**Subject:** MnDOT "hat" bar detail

HAT BAR FOR BEAMS WITH LARGE STOOL HEIGHTS

**Figure 5.4.3.2**

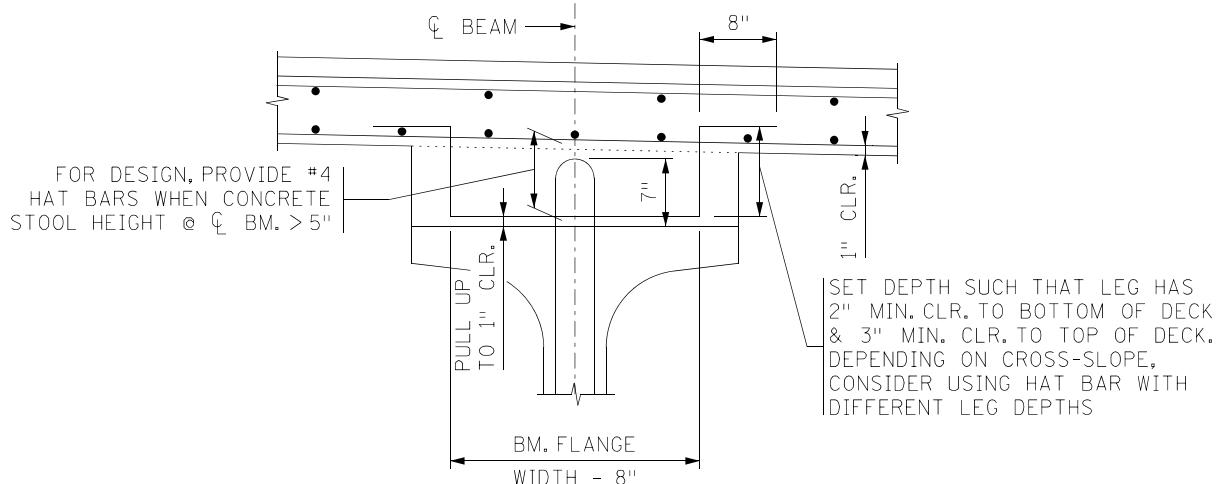
Also, I was a bit surprised to see 4 in. clear on each side from the hat bar to the face of the stool. What is the reason for such a large cover? **We understood that we needed 2-#4 bar legs to match that of the stirrup, and the width wasn't really important. The contractor often has brackets in the outside 4", so we wanted to leave adequate space.**

Do you often use bars with different leg heights to accommodate cross slopes? Or is that only required when the cover requirements can't be satisfied on both sides? **Typically, we would use the same leg height on both sides, but we allow for different leg lengths when the cross slope dictates. It doesn't happen often, but we have done it on occasion.**

I see that the hat bar is not allowed to sit on the top of the girder, but it is pulled up for 1 in. clear. What was the reason for that, and has it worked well in the field? **The bar is held up an inch to provide some concrete cover. It prevents the bar from sitting right at the cold joint where moisture could potentially get to the bar and cause deterioration. To the best of my knowledge, it has worked well.**

Have longitudinal bars at the bottom of the hat bars been considered to enhance the anchorage at the bottom? That is a detail I have seen somewhere. **The reason the details requires the leg to come up over the bottom longitudinal bars is to help anchor the bars. We've seen that detail a couple of times, but we don't really think there's a need.**
